# Access Compliance Report

## Public Rights-of-Way

| Intersection ID: 2843 | Main Street: RIDGEFIELD_DR | Cross Street: WATERELM_LN | Location: NW           |
| ADA ID: 1849BCD28DE6  | Ramp Type: BlendTrans1     | Initial Pass/Fail: Pass   | Overall Compliance: No |

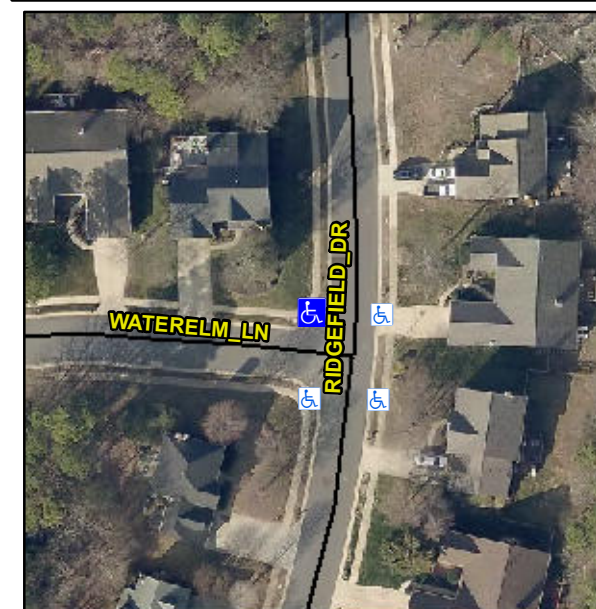
**Not Found, R304.5.3, R304.2.1, R304.2.2-Perp, R304.3.2-Para, R305, R304.5.4**

| Compliance | Description           | Data | Compliance | Description                 | Data |
|------------|-----------------------|------|------------|-----------------------------|------|
| Yes        | Ramp Width (in)       | 48.0 | No         | BlendTrans XSlope (%)       | 2.9  |
| Yes        | Landing Length (in)   | 48.0 | No         | DWS Provided?               | No   |
| No         | Landing Width (in)    | 31.0 | N/A        | DWS Contrast?               | No   |
| No         | Landing Slope (%)     | 2.9  | N/A        | DWS Length (in)             | N/A  |
| No         | Landing X Slope (%)   | 2.8  | N/A        | DWS Full Width?             | No   |
| Yes        | Gutter Ponding?       | No   | No         | Gutter Slope (%)            | 8.1  |
| Yes        | Gutter Lip Ht (in)    | 0.0  | No         | Gutter X Slope (%)          | 2.2  |

**Remove & Replace Curb Ramp With Two New Directional Ramps or Equivalent. Remove & Replace Gutter.**
